**STAFF REPORT
WEST ALLIS PLAN COMMISSION
Wednesday, February 28, 2024
6:00 PM
West Allis City Hall – Room 128**

2. **Site, Landscaping, and Architectural Design Review for an accessory parking facility, at 9422-30 W. National Ave. submitted by John Fuchs and Nick Fuchs on behalf of Milwaukee Entertainment, LLC (Tax Key No. 479-0674-003).**

Temporary wall proposal provided by Achtenhagen Services Inc.

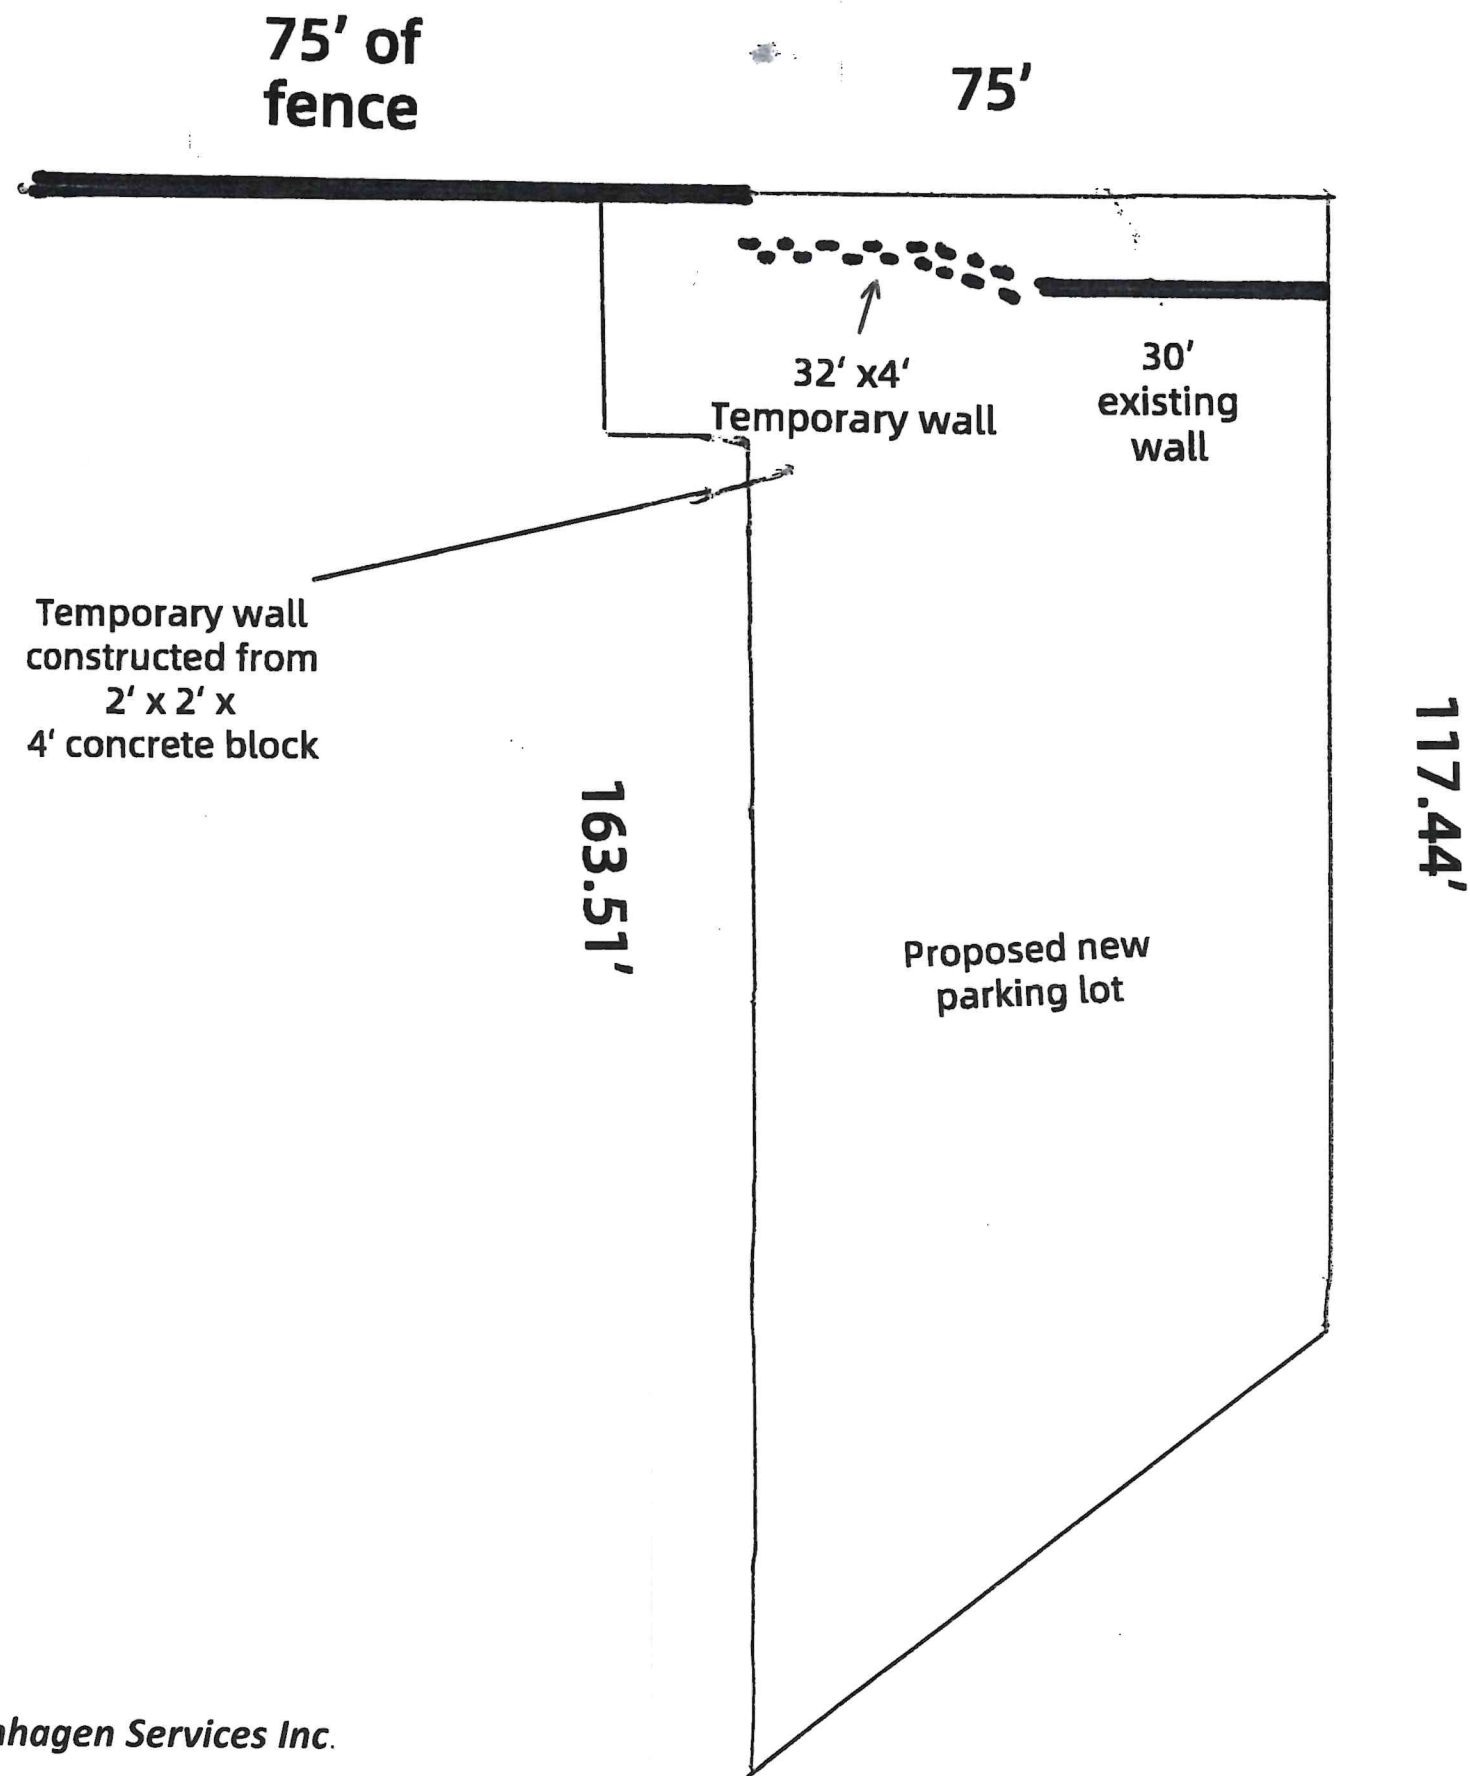
- Temporary fence/wall needs more clarity/detail. Actual plans of what the wall is going to be made from how it will be constructed, and its location need to be submitted for review. The original plan calls for 2'x2'x4' blocks and the new plans call for 6" blocks. The plans should match. Appears that the existing retaining wall will be removed for a temporary one and in the same approximate location.

- What is the term of the interim wall, and when will the permanent wall be completed?
- There is a large "landscape" area between the retaining wall and the property line. This adds stability to the garage. Removing it and moving the retaining wall closer will have a different loading. Even though the wall is less than 5 feet tall, Engineering is recommending that a structural engineer review and stamp the permanent retaining wall plans.

1. An estimated cost of construction and surety bond or other form of security as required under Sec. 19.13 of the Revised Municipal Code in the amount of 125% of the estimated cost of site stabilization and retaining wall shall be executed by the applicant prior to the issuing of a building permit.
2. Revised retaining wall plans being submitted for Engineering review. The plan details conflict and require more detail the revised cross-sectional detail plan shows different retaining methods/materials than the site plan. Location of interim wall and future/permanent wall need to be understood.
3. Interim wall location, term of use, and construction schedule indicating the start and completion of the permanent wall.

SHEET NO. C-3

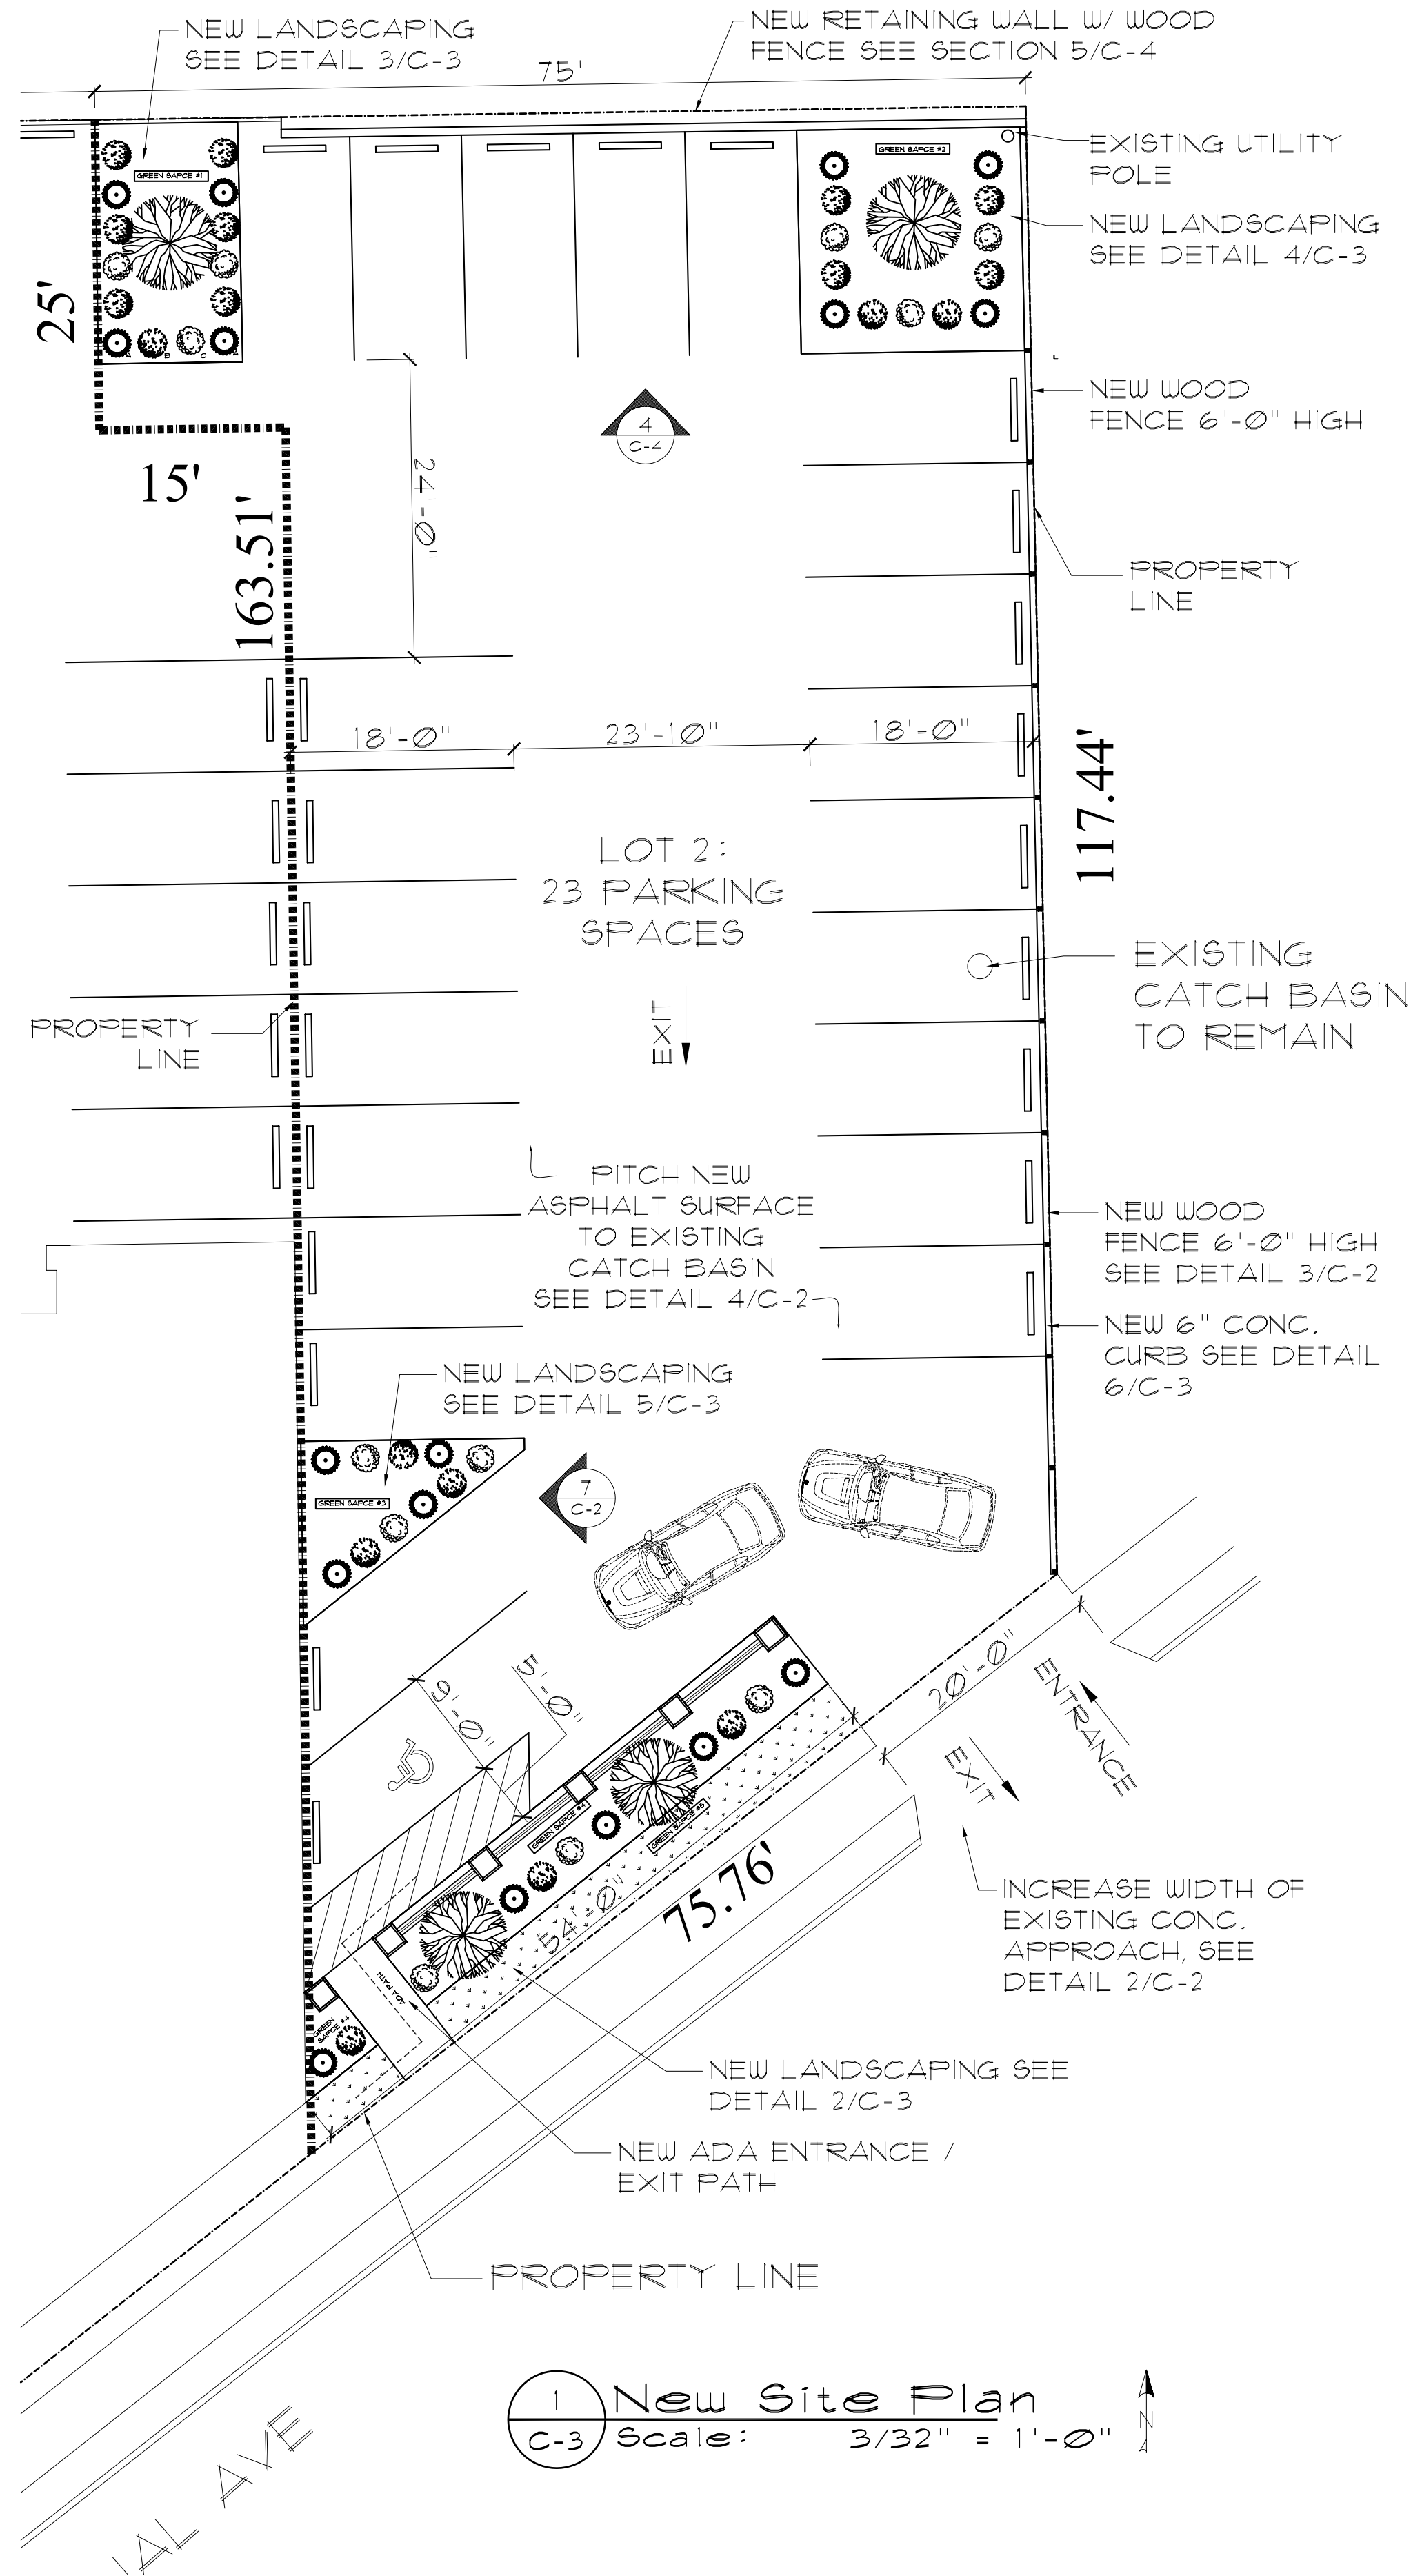
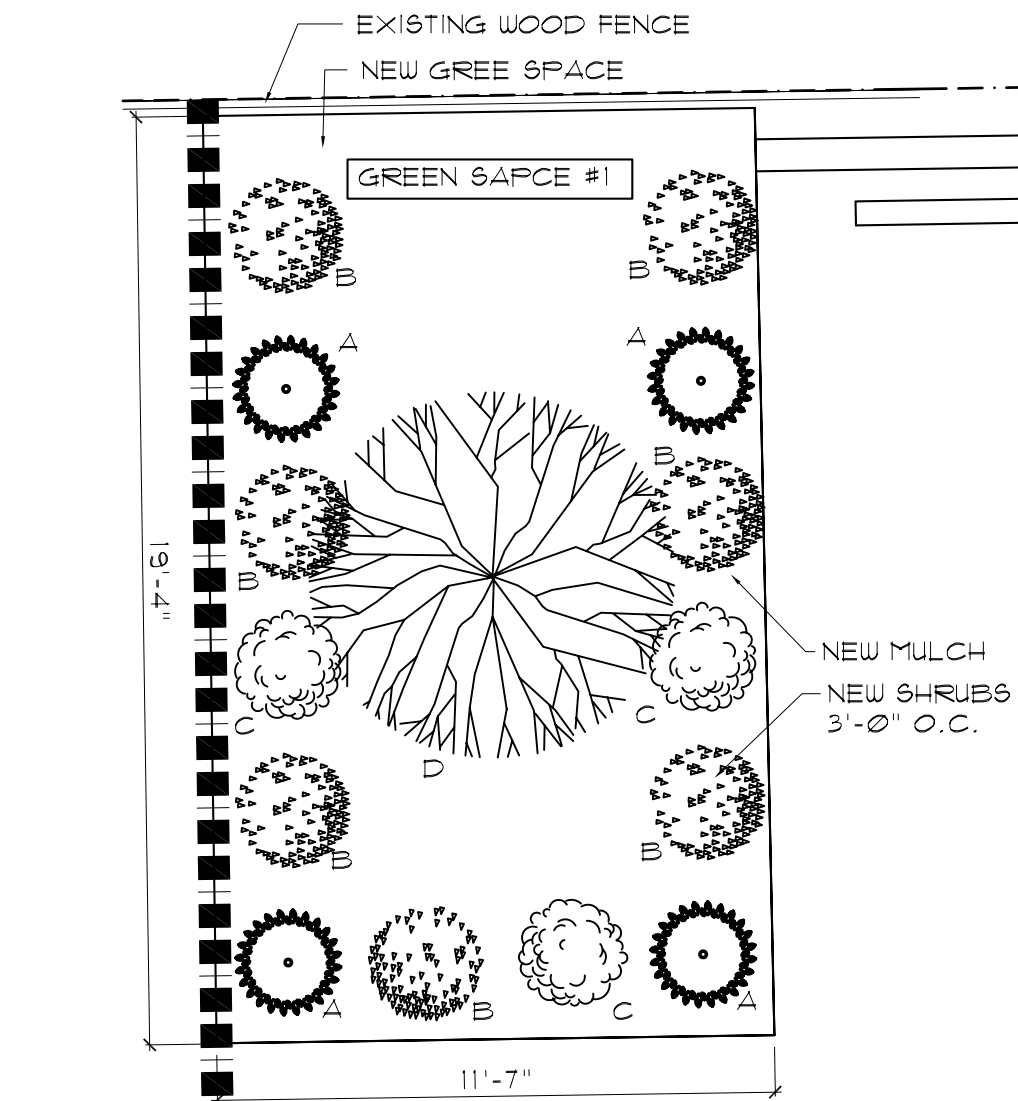
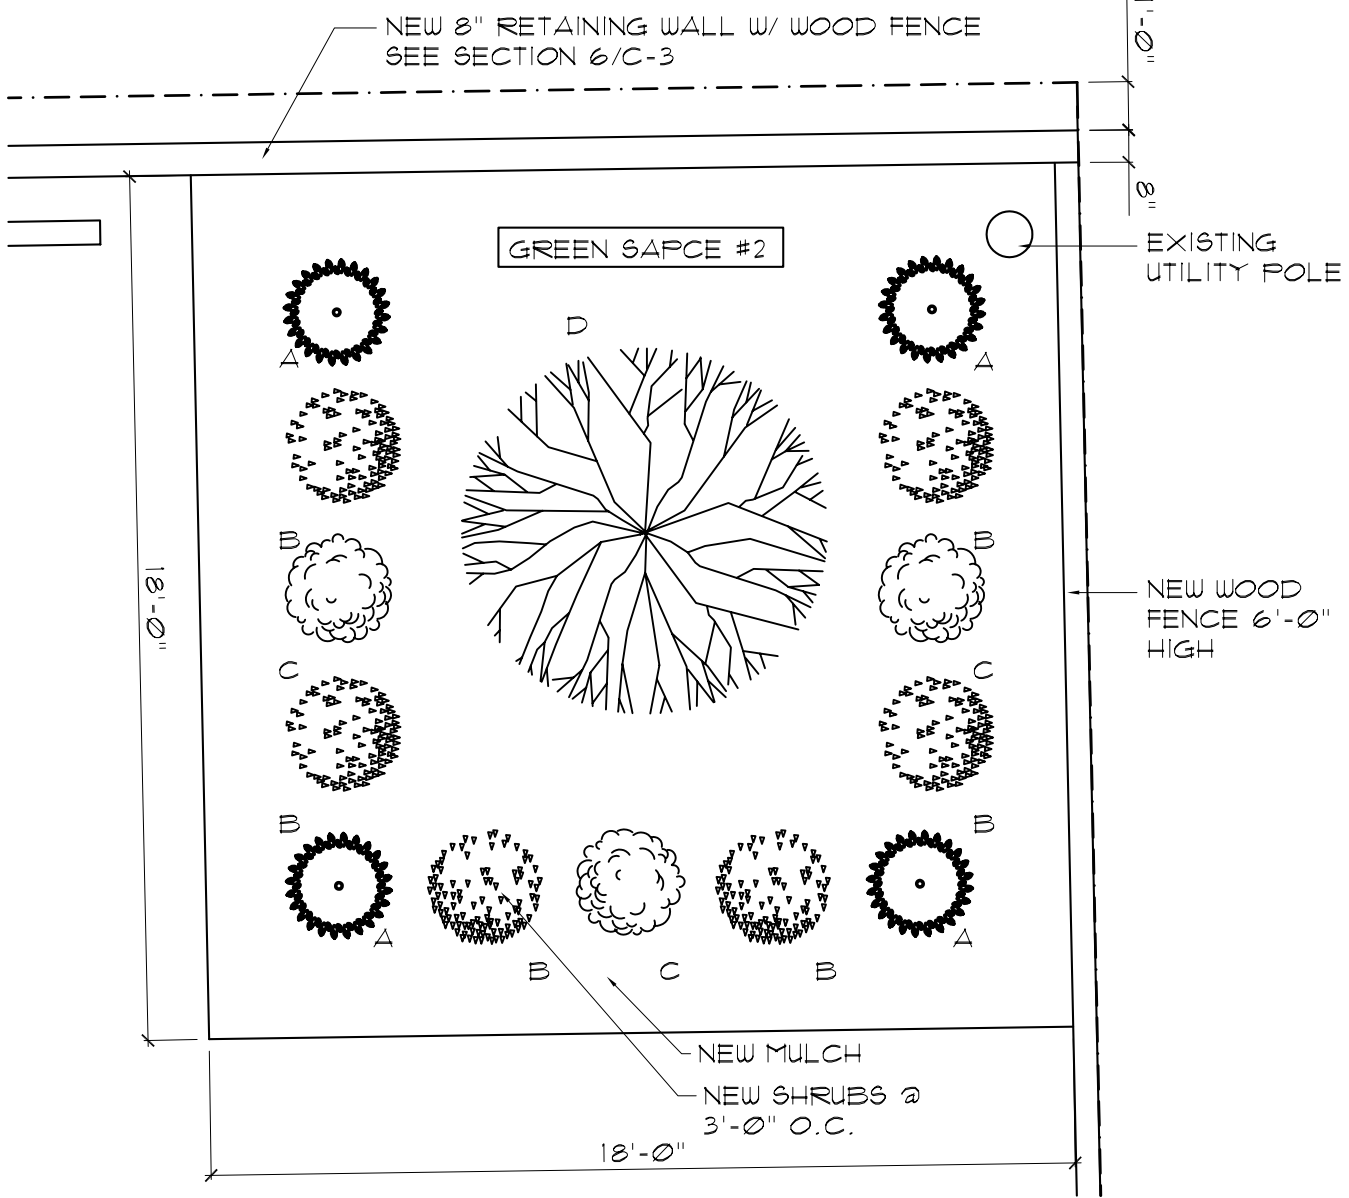
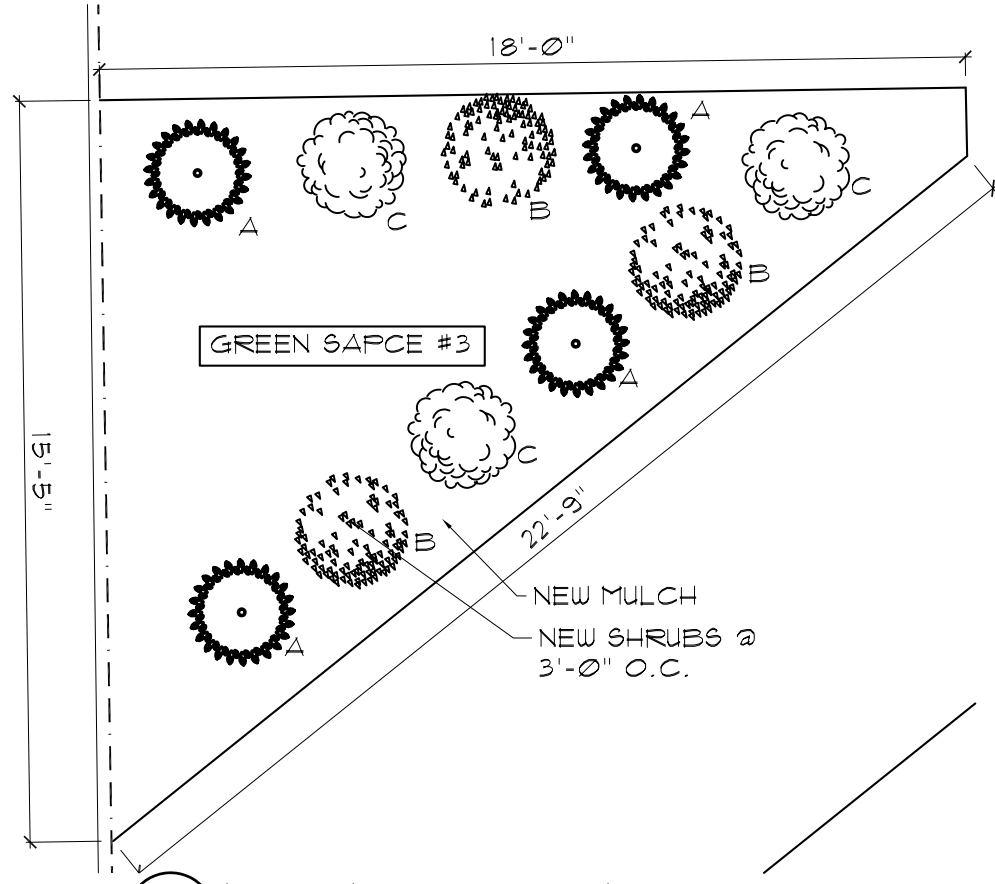
- The retaining wall plans show a drain tile being added on the north side of the wall. Where is it draining (the outlet) shall be shown on the plans. A grading plan is recommended to be submitted as part of the project to understand where the drainage is going. No spot grades are on any plan. Sheet C-3 states there is a detail on C-4 for an existing catch basin, but not seeing it.

8. Documentation and approval showing compliance that existing catch basin on site is designed to accommodate storm water for new parking area.
